Access Compliance Report

Public Rights-of-Way

(Curb Ramps)

Intersection ID: 30307	Main Street: BLACK_KETTLE_DR	Cross Street: FLYING_SCOTSMAN_DR	Location: SE
ADA ID: 8A9413ACA6DD	Ramp Type: PerpDiag	Initial Pass/Fail: Fail	Overall Compliance: No
Severity Score: 10			
Codes/Mitigation Info/Possible Solution		Field Measurements/Component Compliance

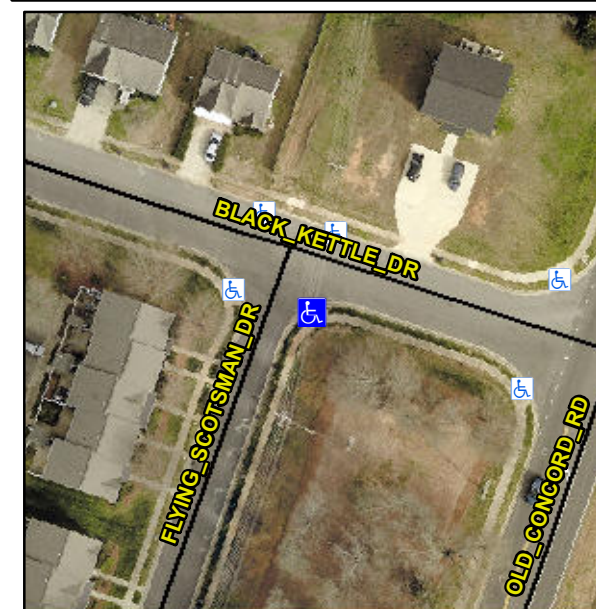
Not Found, R304.5.1, R304.5.3

Compliance	Description	Data	Compliance	Description	Data
N/A	Ramp Length (in)	46.0	Yes	Ramp Slope (%)	6.7
No	Ramp Width (in)	42.0	No	Ramp XSlope (%)	2.2
N/A	Flare Type LT	N/A	N/A	Flare Type RT	N/A
N/A	Flare Slope LT (%)	N/A	N/A	Flare Slope RT (%)	N/A
N/A	Flare Traversable LT?	N/A	N/A	Flare Traversable RT?	N/A
N/A	Landing Length (in)	N/A	N/A	DWS Provided?	N/A
N/A	Landing Width (in)	N/A	N/A	DWS Contrast?	N/A
N/A	Landing Slope (%)	N/A	N/A	DWS Length (in)	N/A
N/A	Landing X Slope (%)	N/A	N/A	DWS Full Width?	N/A
N/A	Landing Curb? (Y/N)	N/A	N/A	DWS Offset (in)	N/A
N/A	Shared Landing?	N/A			
N/A	Gutter Ponding?	N/A	N/A	Gutter Slope (%)	N/A
N/A	Gutter Lip Ht (in)	N/A	N/A	Gutter X Slope (%)	N/A
N/A	Painted X Walk1?	No	N/A	Painted X Walk2?	No
	X Walk 1 Direction	To N		X Walk 2 Direction	To NW
N/A	X Walk 1 Width (in)	N/A	N/A	X Walk 2 Width (in)	N/A
	X Walk 1 Slope (%)	3.8		X Walk 2 Slope (%)	4.2
	X Walk 1 X Slope (%)	3.3		X Walk 2 X Slope (%)	4.2

Remove & Replace Curb Ramp With Two New Directional Ramps or Equivalent.
